# Service Information Bulletin

To: SRAM Customers  
Subject: MY 2019 Lyrik/Yari Lower Leg Recall  
From: SRAM  
Document: SIB#20190702b

Example of casting code 18 O.

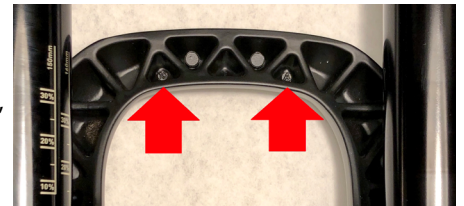
RockShox Lyrik and Yari 29 inch Boost forks within the serial number range of 02T95514009 through 08T96214665 AND having a fork lower with a casting code of "18" and "O" or "19" and "A". The serial number is located on the rear of the fork crown; the casting code can be seen inside the webbing of the arch as shown at right.

The casting code can be found on the inside of the arch web at the red arrows.

Dealers finding any 2019 Yari or Lyrik 29 inch Boost fork within the involved serial number range AND having a casting code of 18 O or 19 A should return the fork to their regional SRAM service point for a free of charge lower leg replacement.
